# Access Compliance Report

## Public Rights-of-Way

### (Curb Ramps)

Intersection ID: 10036434	Main Street: ROXBOROUGH_RD	Cross Street: N/A	Location: NW
ADA ID: 55F7D91208F2	Ramp Type: PerpDiag	Initial Pass/Fail: Fail	Overall Compliance: No
		Severity Score: 12.5

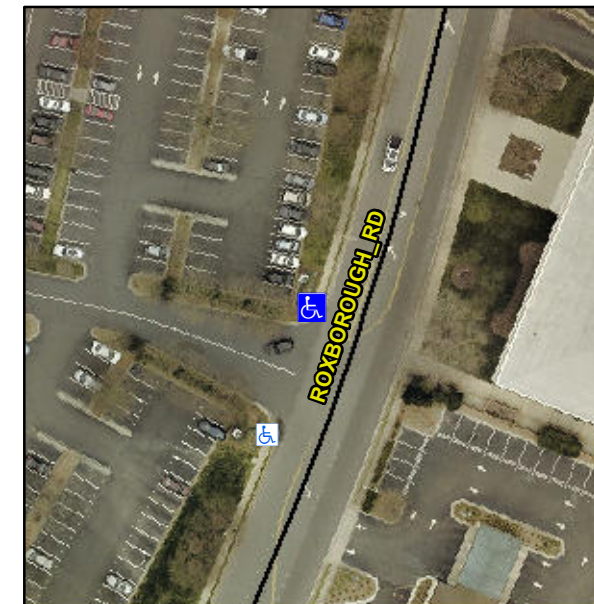
**Not Found, R304.2.2**

Compliance	Description	Data	Compliance	Description	Data
N/A	Ramp Length (in)	43.0	No	Ramp Slope (%)	8.7
Yes	Ramp Width (in)	48.0	Yes	Ramp XSlope (%)	1.6
N/A	Flare Type LT	N/A	N/A	Flare Type RT	N/A
N/A	Flare Slope LT (%)	N/A	N/A	Flare Slope RT (%)	N/A
N/A	Flare Traversable LT?	N/A	N/A	Flare Traversable RT?	N/A
N/A	Landing Length (in)	N/A	N/A	DWS Provided?	N/A
N/A	Landing Width (in)	N/A	N/A	DWS Contrast?	N/A
N/A	Landing Slope (%)	N/A	N/A	DWS Length (in)	N/A
N/A	Landing X Slope (%)	N/A	N/A	DWS Full Width?	N/A
N/A	Landing Curb? (Y/N)	N/A	N/A	DWS Offset (in)	N/A
N/A	Shared Landing?	N/A			
N/A	Gutter Ponding?	N/A	N/A	Gutter Slope (%)	N/A
N/A	Gutter Lip Ht (in)	N/A	N/A	Gutter X Slope (%)	N/A
N/A	Painted X Walk1?	No	N/A	Painted X Walk2?	No
	X Walk 1 Direction	To S		X Walk 2 Direction	To E
N/A	X Walk 1 Width (in)	N/A	N/A	X Walk 2 Width (in)	N/A
	X Walk 1 Slope (%)	4.0		X Walk 2 Slope (%)	6.3
	X Walk 1 X Slope (%)	5.3		X Walk 2 X Slope (%)	2.4

**Remove & Replace Curb Ramp With Two New Directional Ramps or Equivalent.**
